PREVIOUSLY APPROVED
NEIGHBORING PROJECTS

RESIDENTIAL DEVELOPMENT
1165 GREACEN POINT ROAD
MAMARONECK, NY, 10543

**1 SHORE ROAD
Adopted May 20, 2020**

RE: Site Plan Approval
Nauset, LLC
1 Shore Road
Section 155.61, Block 1, Lot 9

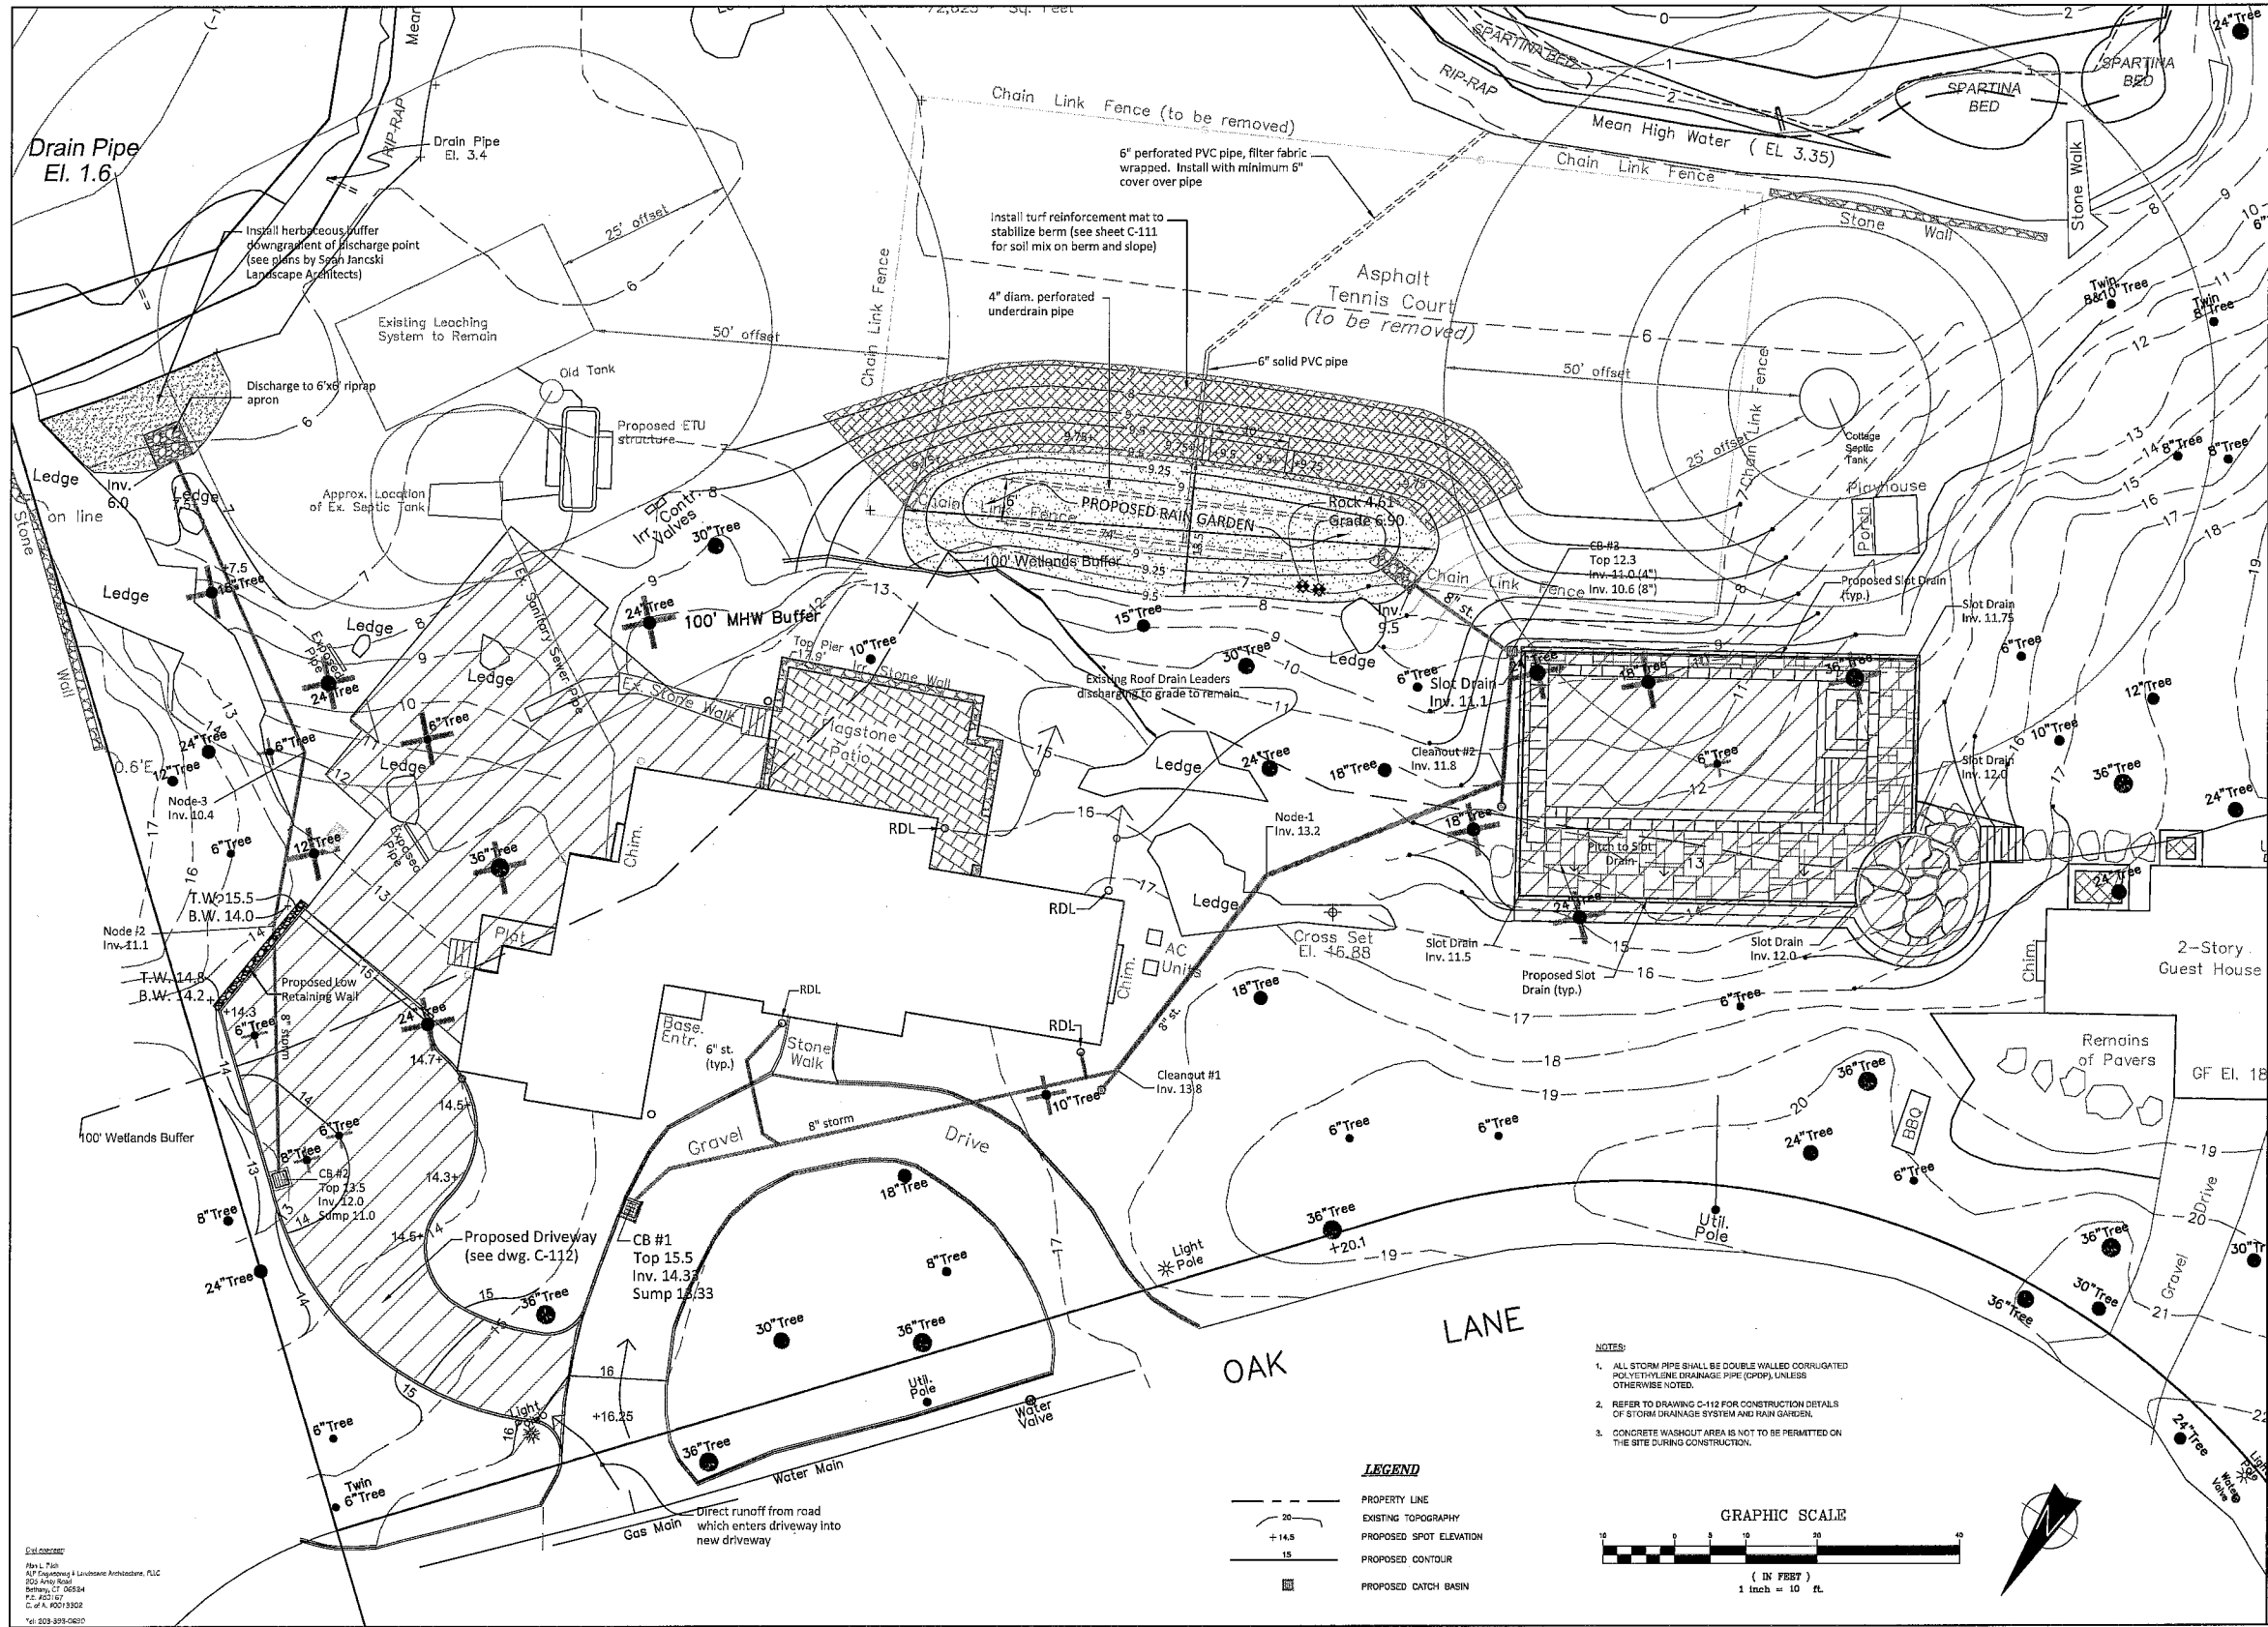
4. The Applicant shall revise the grading on Sheet C-101 to show how the proposed swale leading to the proposed rain garden should be constructed. In addition, the Applicant shall include a detail of this swale on the plans and provide calculations demonstrating that it is designed to convey the anticipated peak flows from the 100-year storm without eroding or overflowing.

7. The Applicant shall consider the installation of a drainage manhole or basin at the southwest corner of the existing property where the storm pipes are shown to intercept on Sheet C-101. The purpose of the manhole or basin is to facilitate the connection, cleaning and maintenance of the pipes.

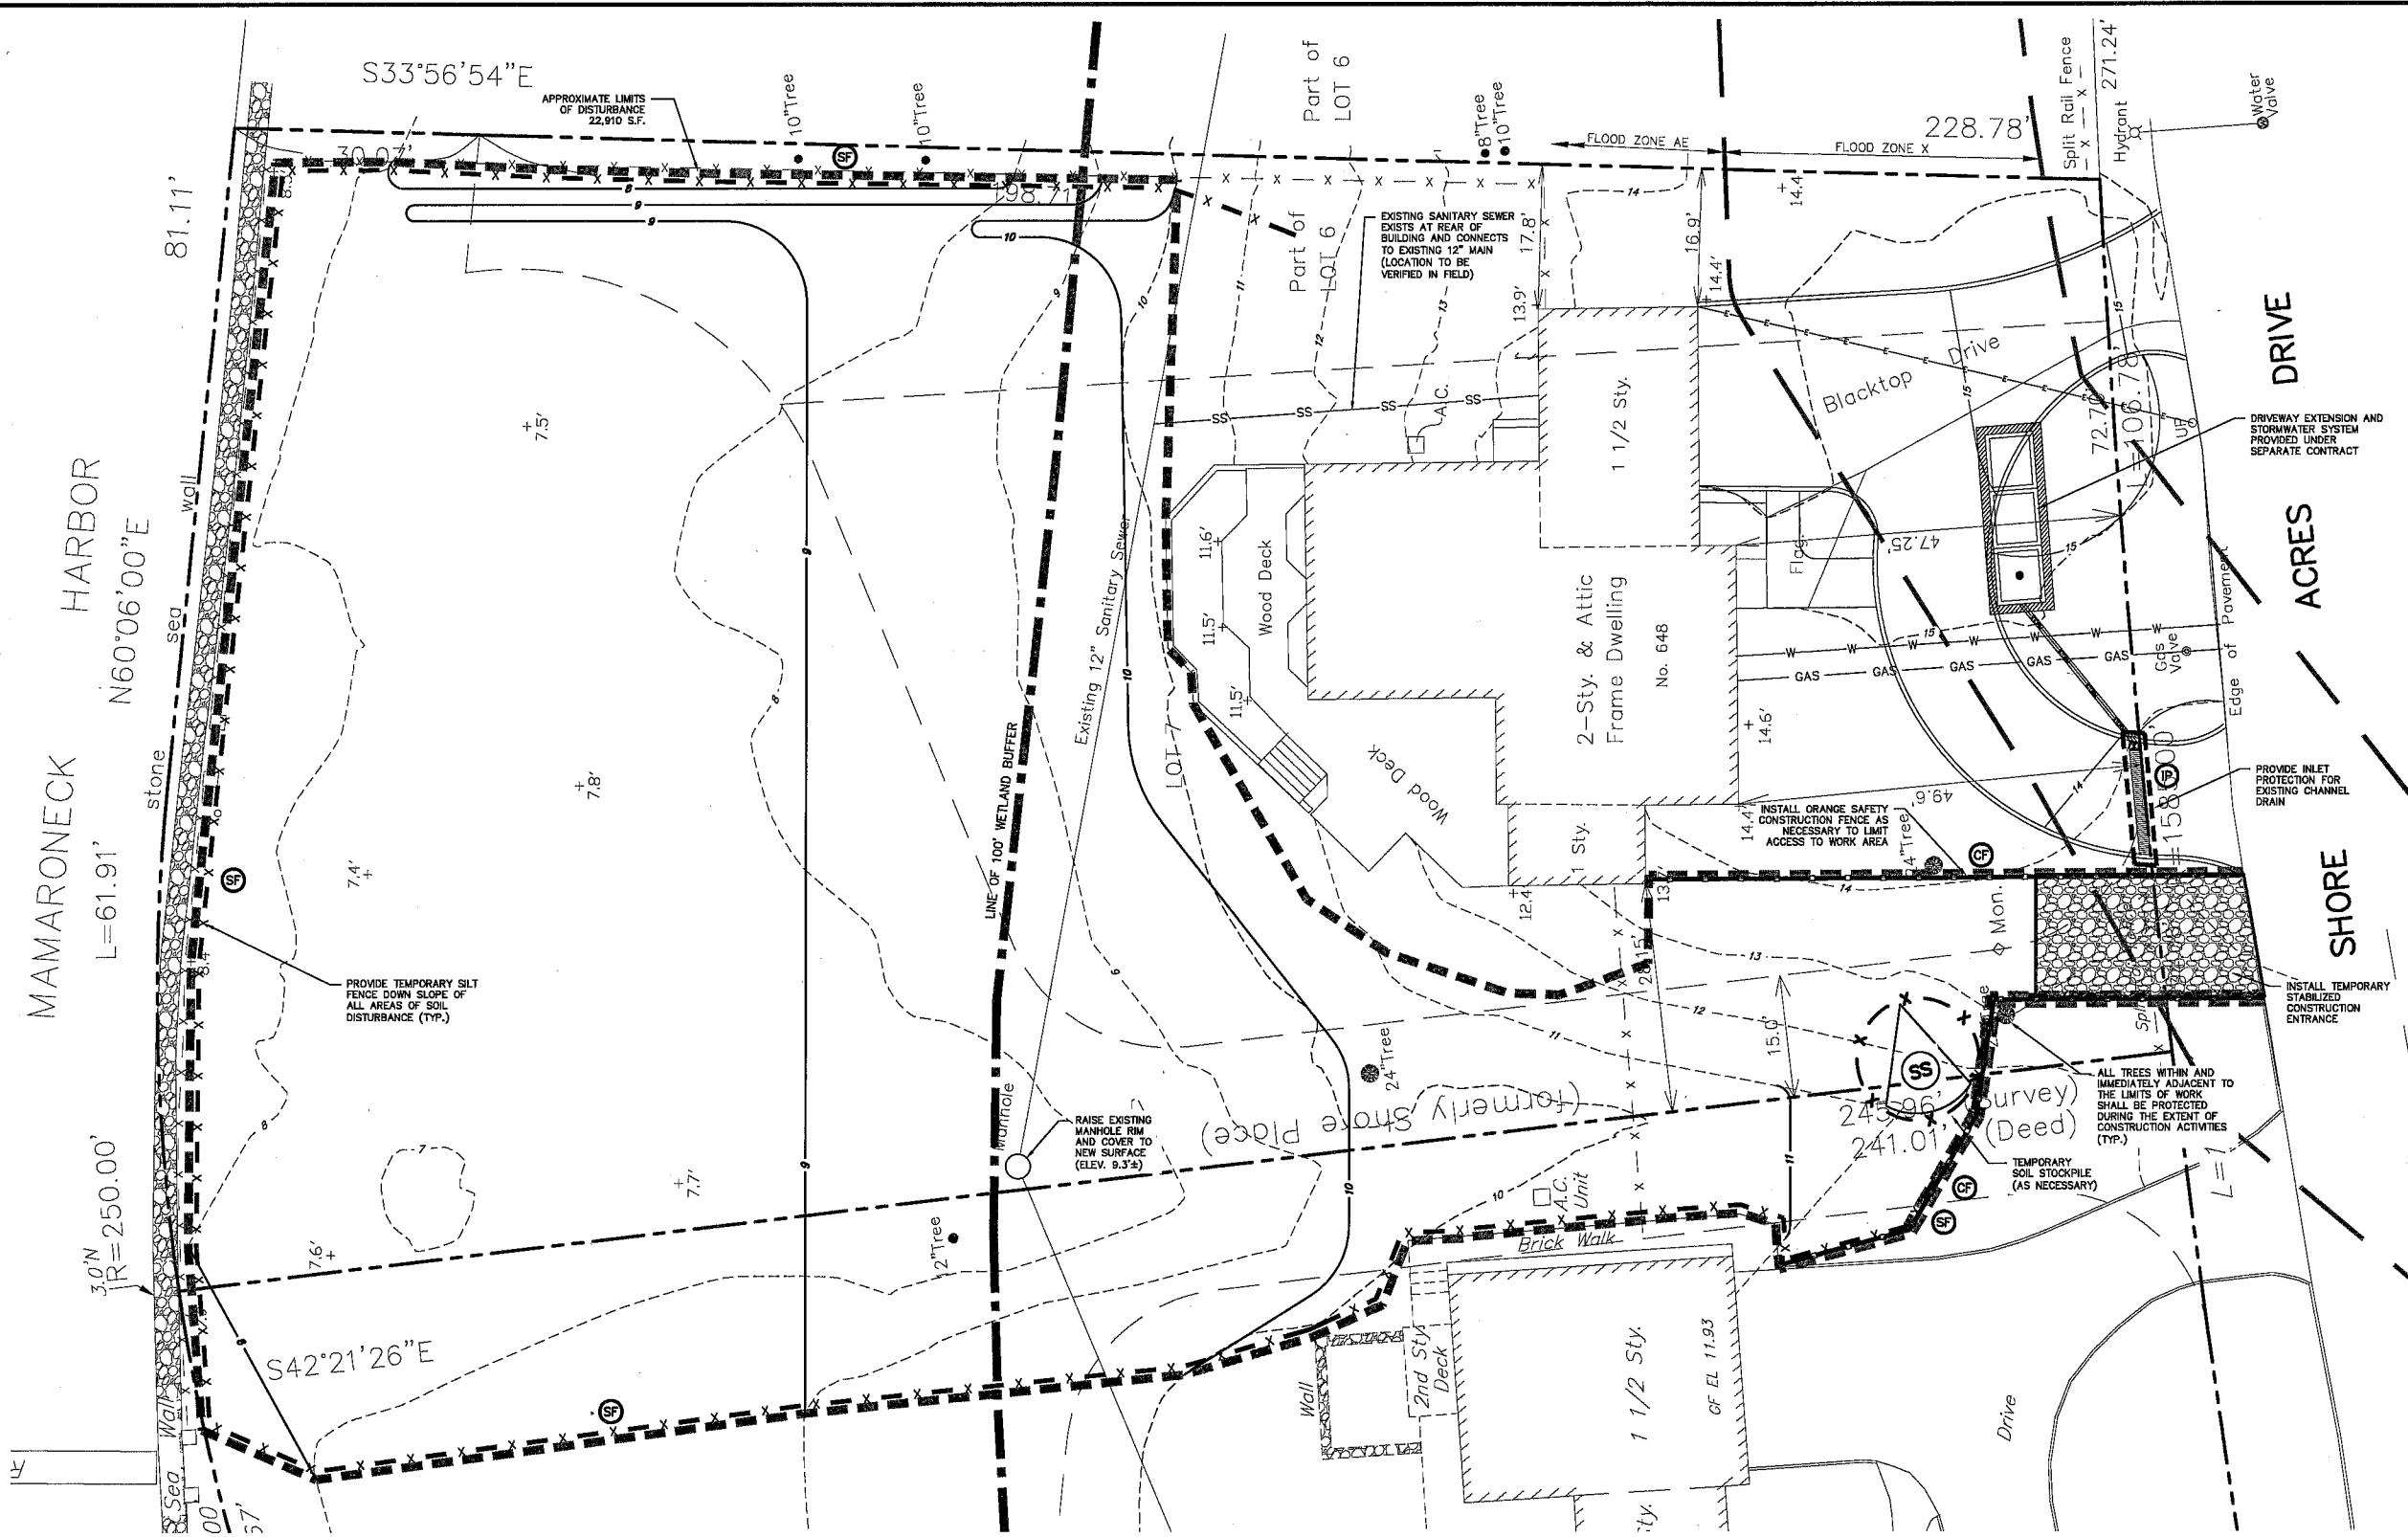
12. The applicant has indicated on the plans that haybales will be installed. The Village does not accept the use of haybales as an erosion control device. The applicant shall consider an alternative sediment-trapping device in the areas where the haybales are proposed to be installed.

13. The Applicant shall revise the note on Sheet C-4 under "Installation & Maintenance of Erosion Control: inspection by Municipality" to indicate the following: "Install all erosion control measures prior to start of construction. Call for inspection form the appropriate municipal agency having jurisdiction at least 2 days prior to installation of erosion control measures."
